**TOPOGRAPHIC SURVEY
SEASPECT SHORT PLAT
JOHN KAHAN**

NO.	DESCRIPTION	DATE
3	PERMIT REVISION	04.19.22
4	PERMIT REVISION 2	06.10.22
5	PERMIT REVISION 3	08.30.22

CLARKSON RESIDENCE
8163 W MERCER WAY
 City of Mercer Island, Washington

1 PROPOSED EAST ELEVATION
1/4" = 1'-0"

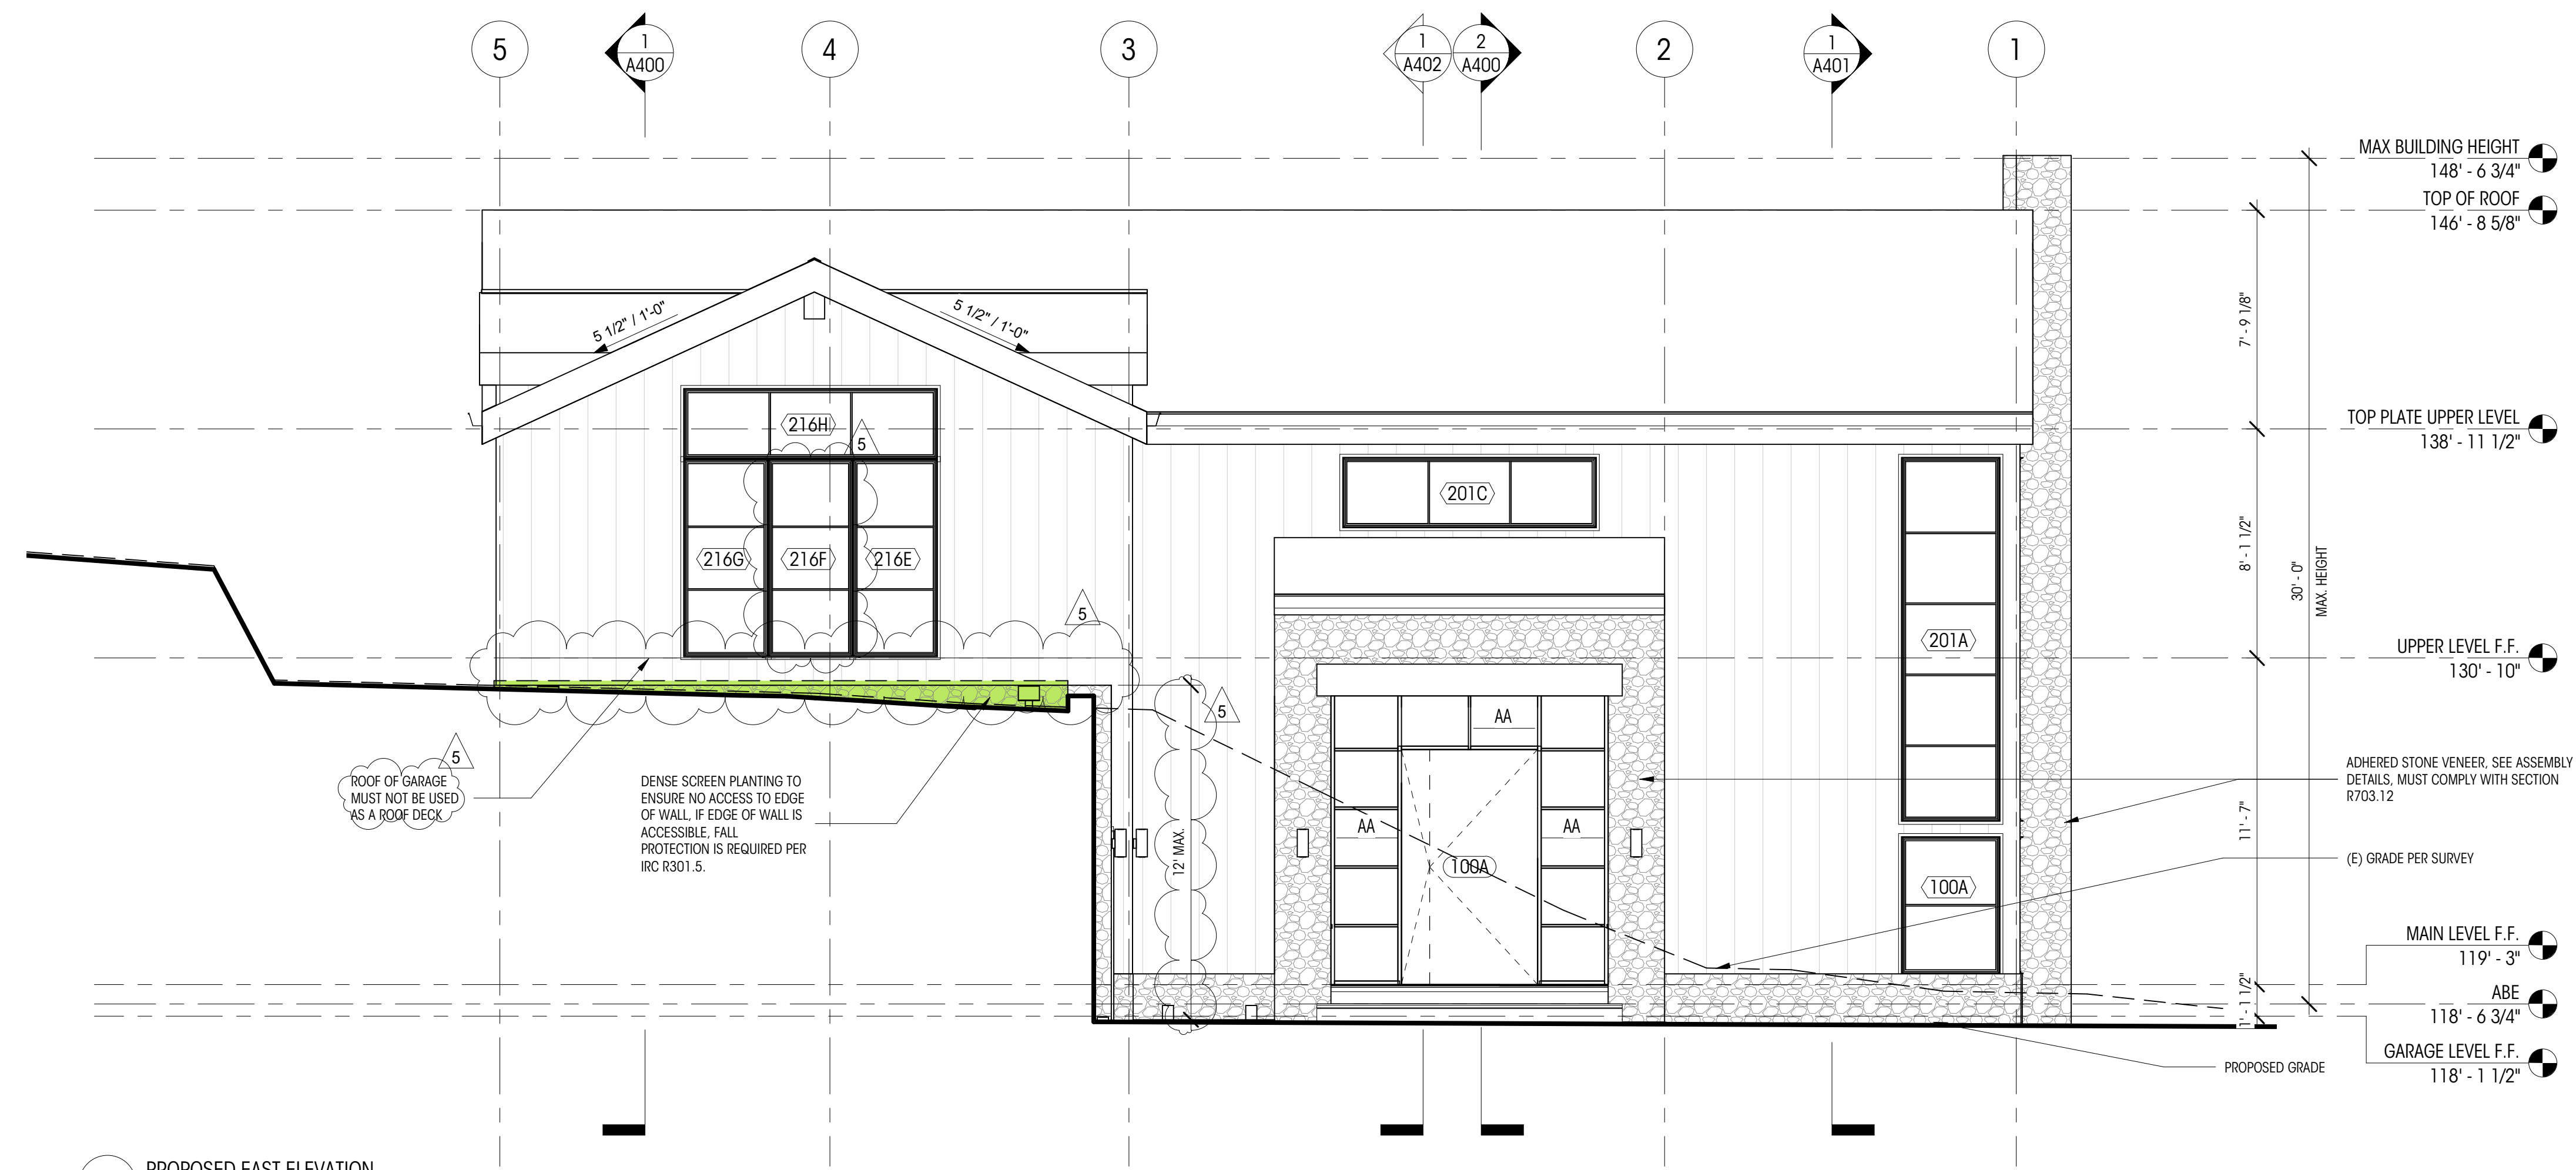
- CHANGE ROOF OF AND EXTEND WESTERN PATIO TO THE WEST AND SOUTH
- ADDED DORMERS AT UPPER LEVEL BONUS ROOM
- EXTEND GARAGE EAST INTO FRONT YARD SETBACK AS ALLOWED BY CODE 19.02.040.D
- WINDOW SIZE & LOCATION CHANGES
- LEVEL CHANGES:
 - a. DRIVEWAY & GARAGE LEVEL DROP BY 12"
 - b. BASEMENT LEVEL DROP BY 12"
 - c. FRAMED FLOOR 12" ABOVE BASEMENT FLOOR.
 - d. CHANGE TO ABE AS A RESULT OF EXTENDED GARAGE AND EXTENDED COVERED DECK
 - e. CHANGE TO MAX HEIGHT AS A RESULT OF THE ADJUSTMENT TO THE ABE
 - f. TOP PLATE LEVEL ADJUSTED UP 2 5/8".

1 EAST WEST SECTION 1
1/4" = 1'-0"

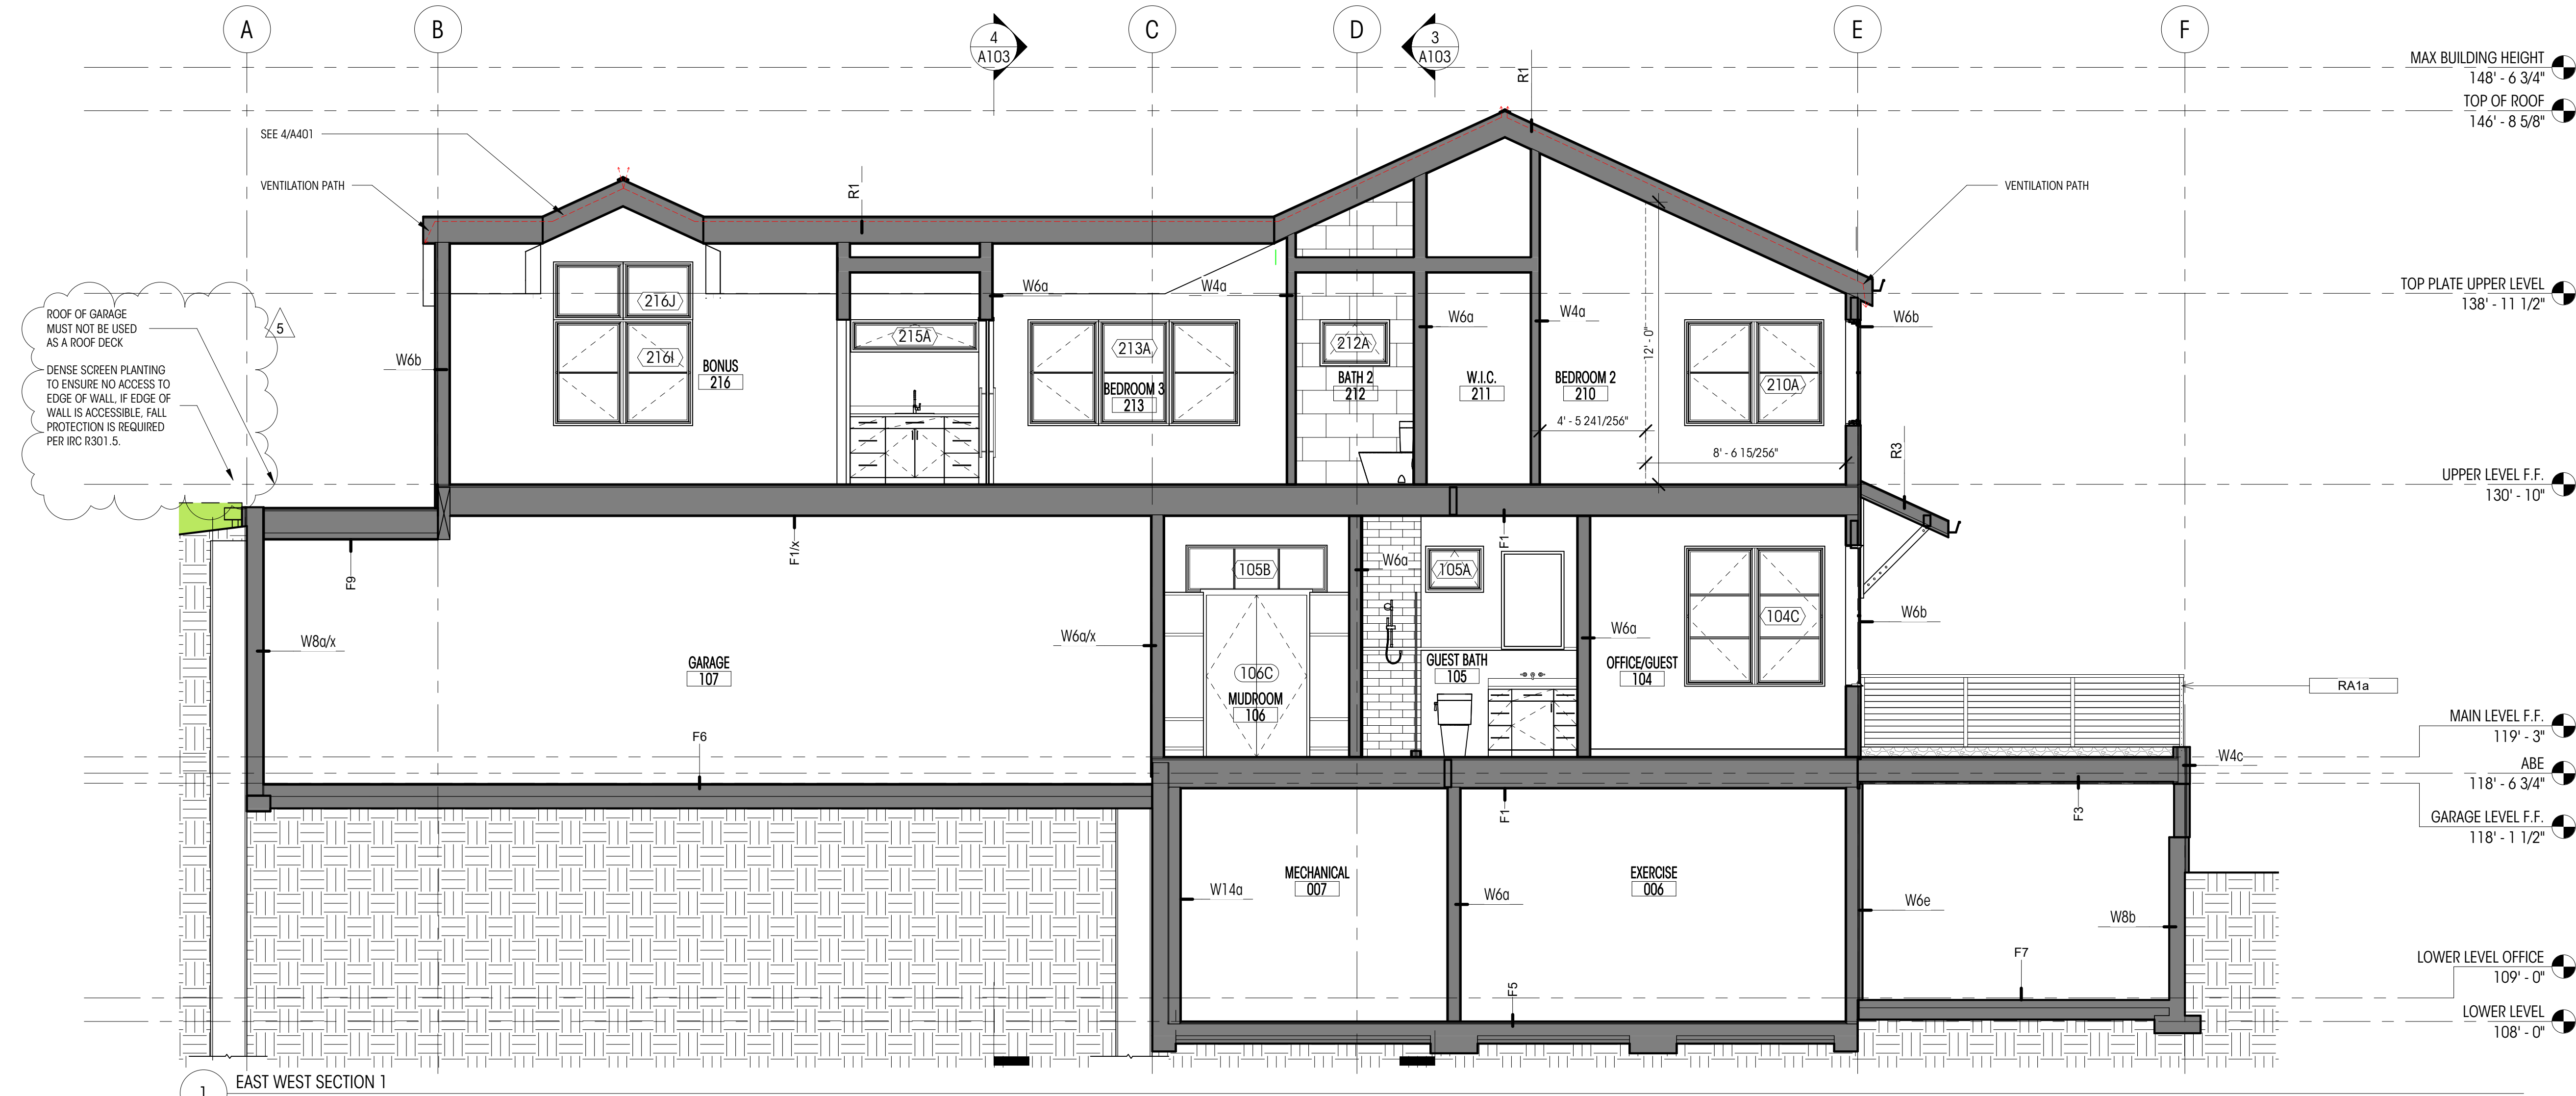
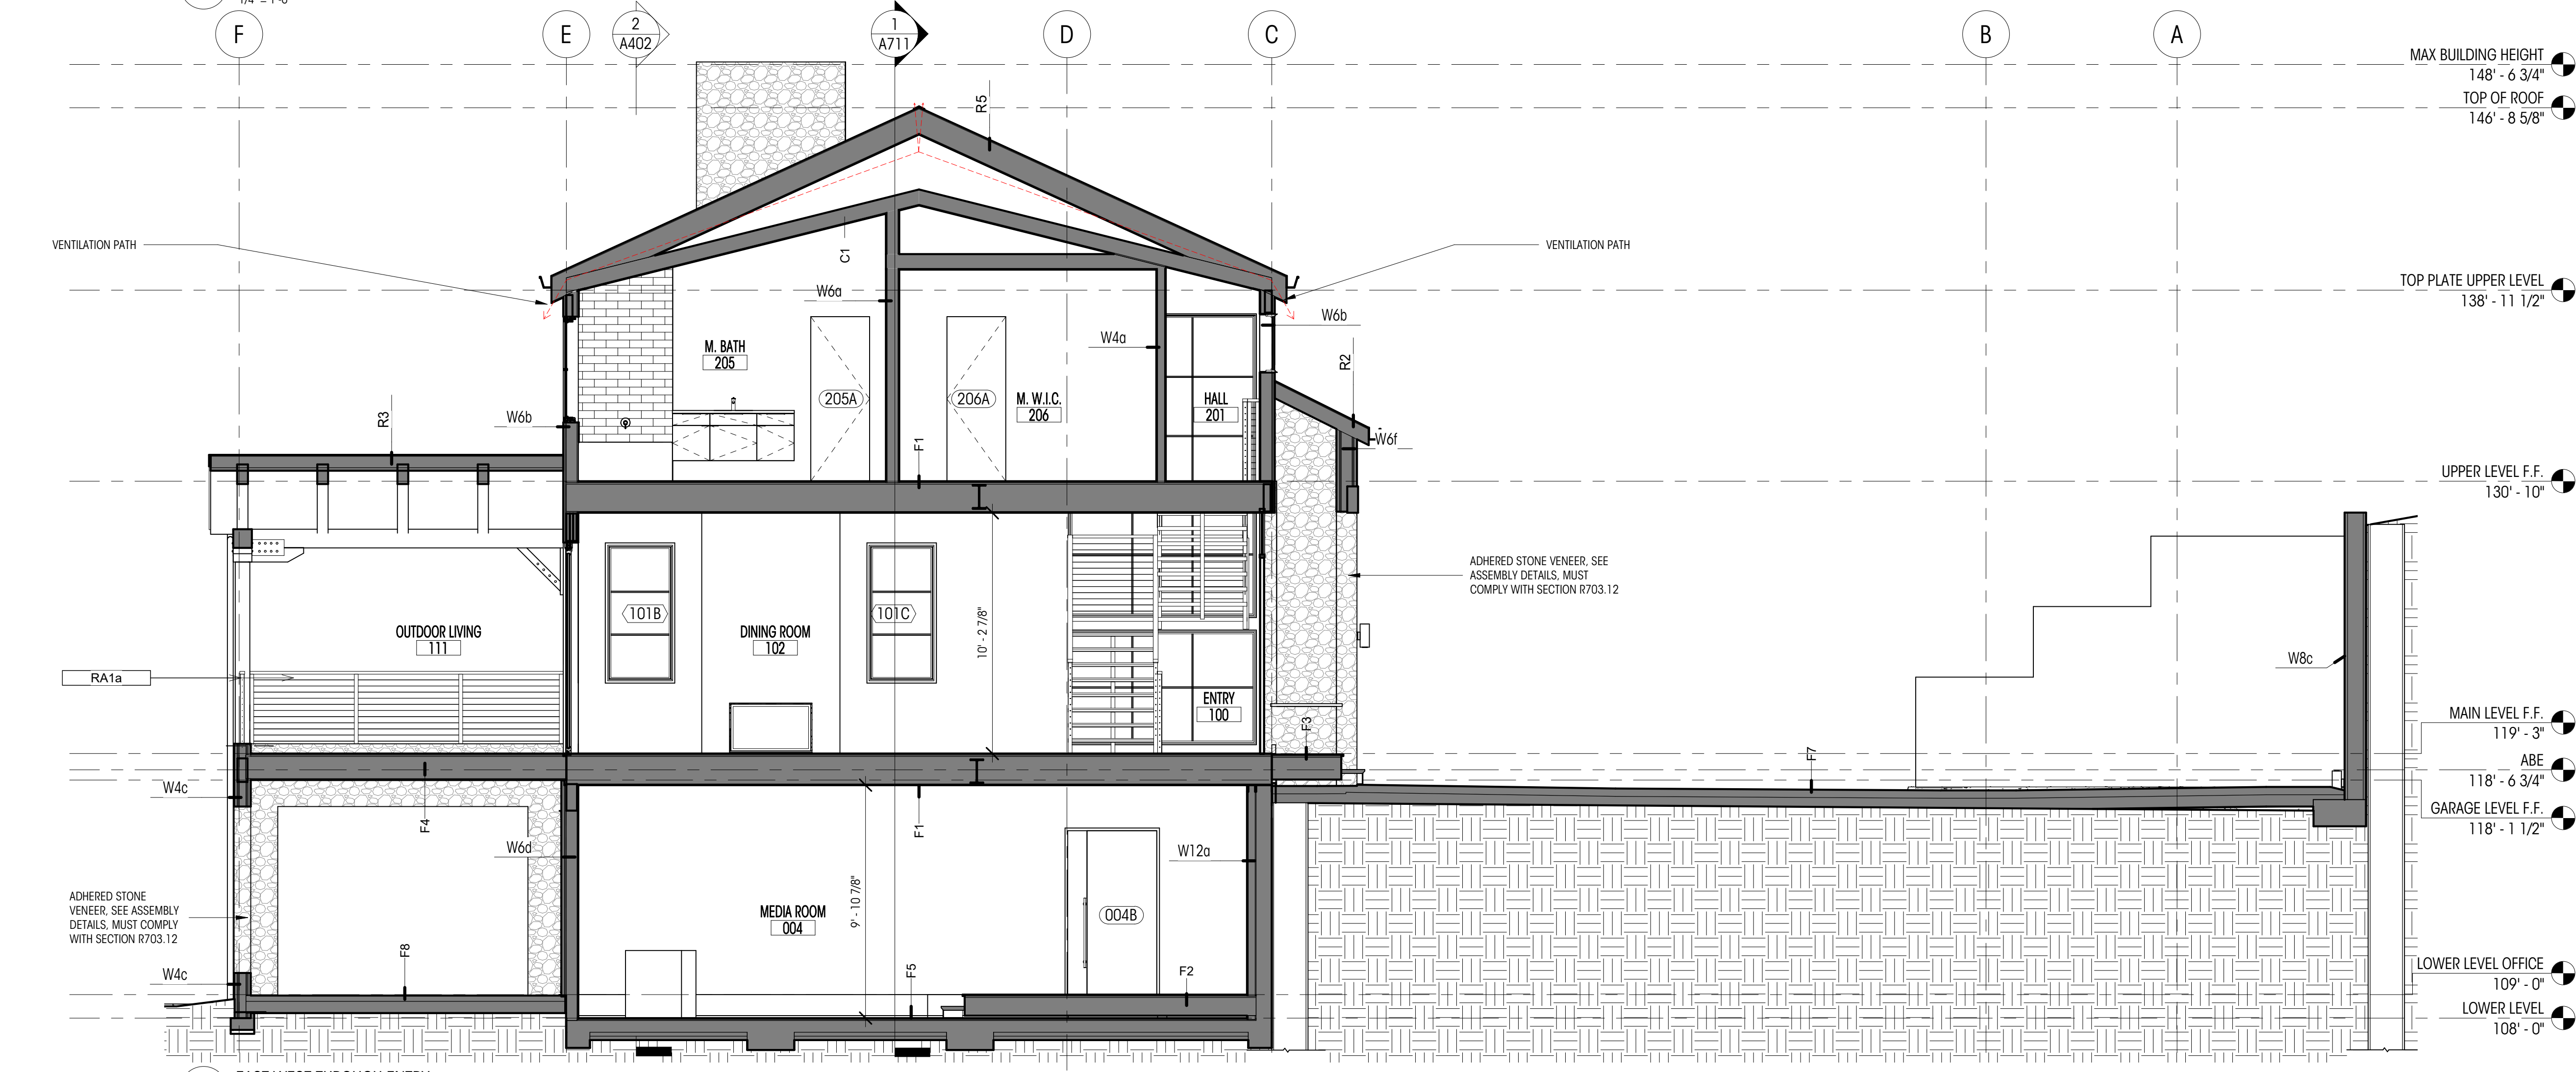
- VIEW NUMBERING UPDATED AND ADJUSTED FOR CLARIFICATION
- CHANGE ROOF OF AND EXTEND WESTERN PATIO TO THE WEST AND SOUTH
- ENTRY DESIGN CHANGE
- ADDED DORMERS AT UPPER LEVEL BONUS ROOM
- EXTEND GARAGE EAST INTO FRONT YARD SETBACK AS ALLOWED BY CODE 19.02.040 D
- SHEET LAYOUT ADJUSTED FOR ORGANIZATIONAL PURPOSES
- PREVIOUS "VIEW 1" HAS MOVED TO SHEET A401 AND STAYED "VIEW 1"

- a. DRIVEWAY & GARAGE LEVEL DROP BY 15"
- b. BASEMENT LEVEL DROP BY 12"
- c. UPPER LEVEL DROP BY 2"
- d. FRAMED FLOOR 12" ABOVE BASEMENT FLOOR.
- e. CHANGE TO ABE AS A RESULT OF EXTENDED GARAGE AND EXTENDED COVERED DECK
- f. CHANGE TO MAX HEIGHT AS A RESULT OF THE ADJUSTMENT TO THE ABE
- g. TOP PLATE LEVEL ADJUSTED UP BASED ON ROOF FRAMING
- h. ROOF OF ROOF HAS LOWERED AS A RESULT OF REDUCED ROOF PITCH
